Author's response

“Characterizing groundwater heat-transport in a complex lowland aquifer using paleo-temperature reconstruction, satellite data, temperature-depth profiles, and numerical models”

Manuscript ID: hess-2021-586.

Response to RC-1 review of the manuscript:

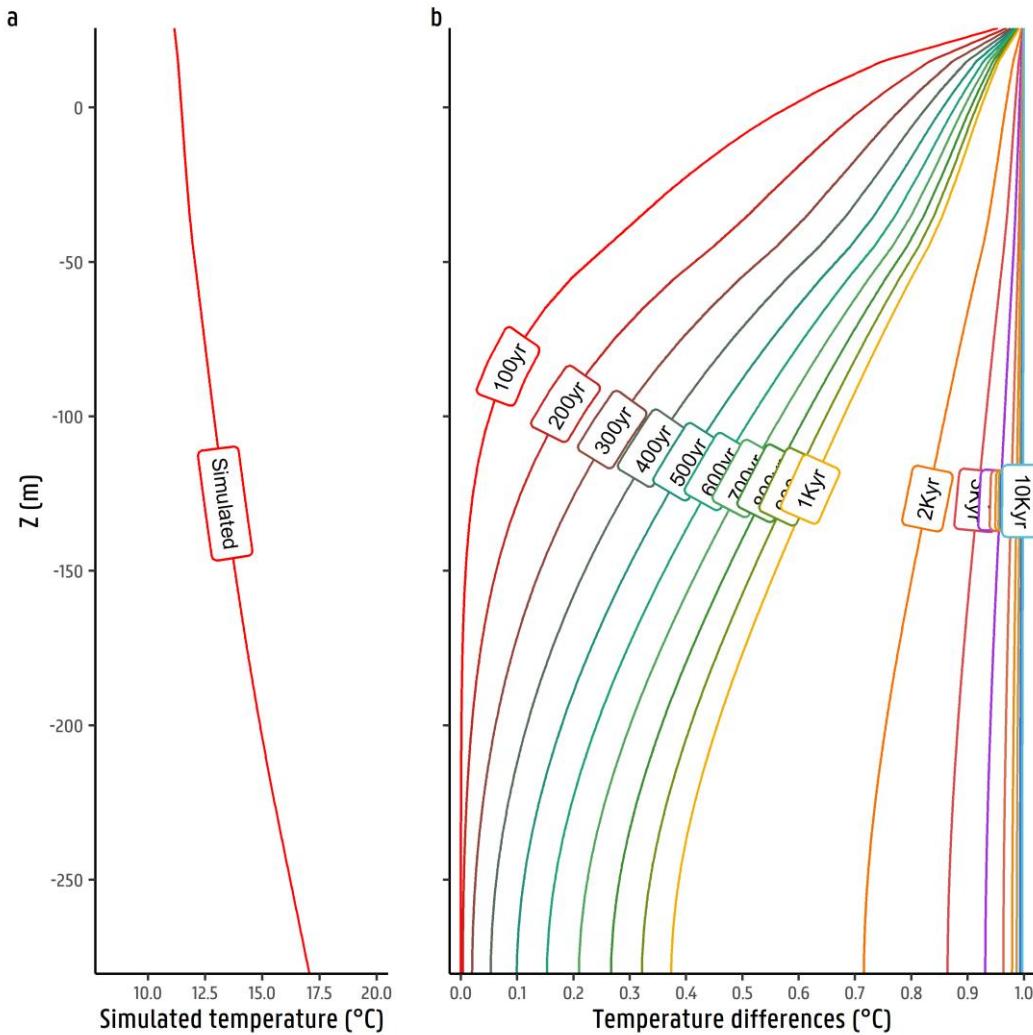
2. I am furthermore not clear of the benefit of running the model based on temperature time series starting in 8500 BC – we do not have accurate data for this far back and more importantly, the model reaches down only 400 m at most, at this depth surface temperatures from maybe a couple hundred years ago are dominating the thermal regime. Hence, I must recommend focusing rather on high-frequency and more accurate data that's a bit more

recent than on long time-series such as paleo-temperatures (e.g., climate reanalysis data such as ERA 5 or MERRA-2 or GISS Model E2).

Certainly, no accurate data exists for this far back. However, temperature reconstructions from an exhaustive list of published works (i.e. Buntgen et al., 2011; Casty et al., 2007; D'Arrigo et al., 2005, 2006; Esper et al., 2014; Glaser and Riemann, 2009; Ljungqvist et al., 2019; Luterbacher et al., 2016; Mann, 2002; Mann et al., 2009; Marsicek et al., 2018; Tingley and Huybers, 2013) that are widely accepted have been used to infer a temperature value to be implemented as initial condition for the heat-transport model top boundary condition.

To increase the accuracy of the simulated temperature, hence a good simulated vs observed temperature performance, the simulated temperature has to be able to stabilize (or reach a steady-state) and for this we require to estimate these initial conditions (initial temperature values for each stress period).

To demonstrate the importance of performing the paleo-temperature simulations and provide suitable initial conditions for each stress period, a test was performed. (Disturbed) Simulations were performed where the initial top boundary condition was disturbed by increasing 1 degree (°C) of temperature at various time steps (years before present i.e. 10,000yr, 9,000yr, 8,000yr, 7,000yr, 6,000yr, 5,000yr, 4,000yr, 3,000yr, 2,000yr, 1,000yr, 900yr, 800yr, 700yr, 600yr, 500yr, 400yr, 300yr, 200yr, 100yr) and for the remaining time-steps of the simulation period. The simulated temperature-depth (TD) profile from each of these models was obtained for the same location (on well R-54f). The results of this test are shown in Figure 1. In Figure 1a, the simulated TD profile at the last time step (present time) from a normal (undisturbed) forward model run is shown. In Figure 1b, the differences between the disturbed and normal (undisturbed) simulated TD profiles are shown, pointing out the time required for the model to reach a steady-state given a change of 1 degree in the top boundary temperature condition. This shows that a couple of hundreds of years are still not sufficient to achieve a steady-state condition, particularly in the deeper areas near the bottom of the aquifer. For the purposes of our study, it is important to be able to reach this stability at these depths.

This supports the use of a relatively long time series which is actually a process that is not computationally intensive. The model in total has 337 stress periods (accounting the paleo-temperature time series for 111 steps, and 226 for the LST stress periods) and runs in around 40 minutes. For the 9 time steps in the stress period between 10,000yr and 2,000yr before present (in steps of 1,000 years) it requires around a minute (approximately 64 seconds) to compute, offering the considerable temperature gain (better performance) of up to 30% per temperature degree of change at the temperature top boundary condition. Having a higher frequency temperature distribution is not within the scope of this work, as we are more interested in knowing what improvement the implementation of an additional state variable may bring to the

conceptualization of the groundwater system rather than aiming for higher frequency results, for which monthly time-steps seem reasonable.

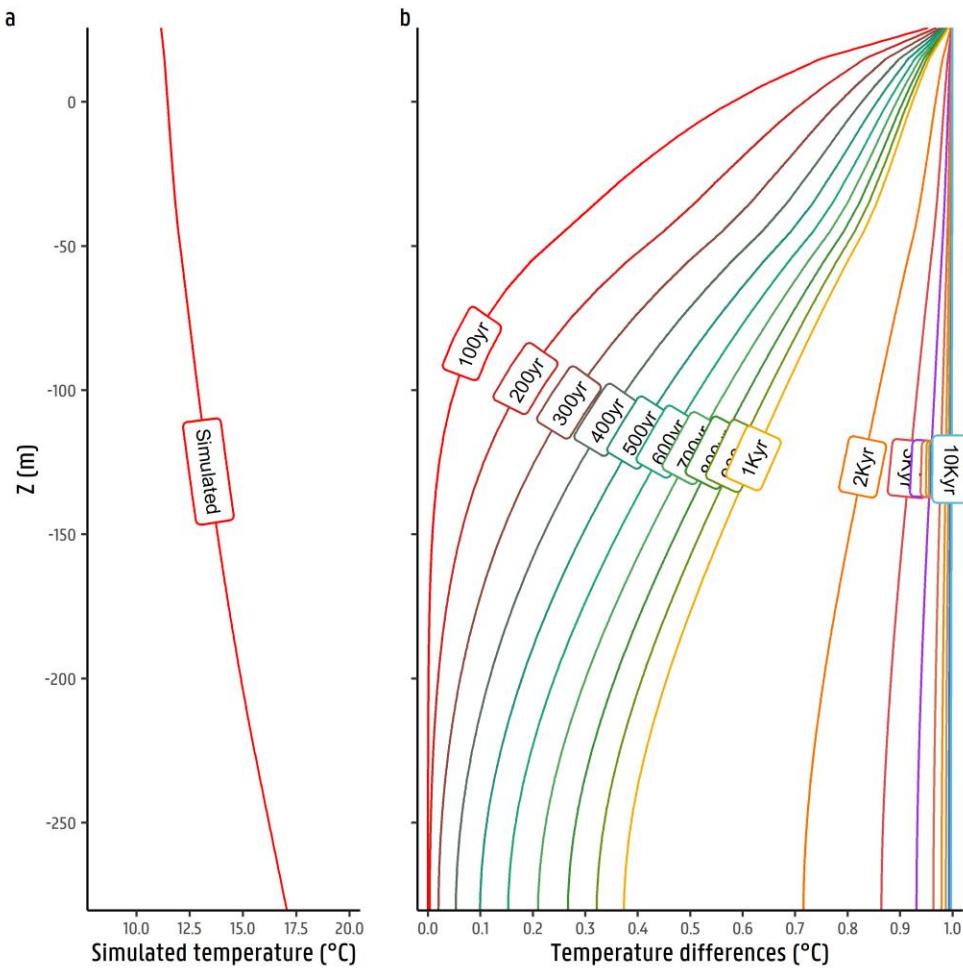
1. It is not clear why the model needs paleo-temperature to work. Also, I really doubt that simulating 10519 years yields meaningful results, given that the flow model is stationary.

To increase the accuracy of the simulated temperature and hence a good simulated vs observed temperature performance, the simulated temperature has to be able to stabilize (or reach a steady-state) and for this we require to estimate initial conditions (initial temperature values for each stress period).

To show the importance of performing the paleo-temperature simulations and to provide initial conditions for further stress periods, a test was performed. (Disturbed) simulations increasing 1 degree (°C) of temperature at the initial top boundary condition at various time steps (years before present i.e. 10,000yr, 9,000yr, 8,000yr, 7,000yr, 6,000yr, 5,000yr, 4,000yr, 3,000yr, 2,000yr, 1,000yr, 900yr, 800yr, 700yr, 600yr, 500yr, 400yr, 300yr, 200yr, 100yr) and for the remaining of the simulation period were performed. The simulated temperature-depth (TD) profile from each of these models was obtained for the same location (on well R-54f). The results of this test are shown in Figure 1. On Figure 1a, it is shown the simulated TD profile at the last time step (present time) from a normal (undisturbed) forward model run. On Figure 1b, the figure shows the differences between the disturbed and normal (undisturbed) simulated TD profiles, pointing out to the time required for the model to reach a steady-state given a change of 1°C in temperature at the top boundary condition. This supports the use of a relatively long time series which, actually, is a process that is not computationally intensive. The model in total has 337 stress periods and runs in around 40 minutes For the 9 time steps in the stress period between 10,000yr and 2,000yr before present (in steps of 1,000 years) it requires around a minute (approximately 64 seconds) to compute offering a temperature stabilization of up to 30% per temperature degree of change in the temperature top boundary condition.

Similarly as done in previous works in the area (Casillas-Trasvina et al., 2021; Gedeon, 2008; Rogiers et al., 2015), and as indicated in the body of the manuscript (section 3.2.1 Conceptual model, line 215), the aquifer is assumed to be in dynamic equilibrium, with no long-term trends in groundwater fluxes, which allows us to simulate the groundwater flow in steady-state. For the purposes of our research we find this assumption acceptable.
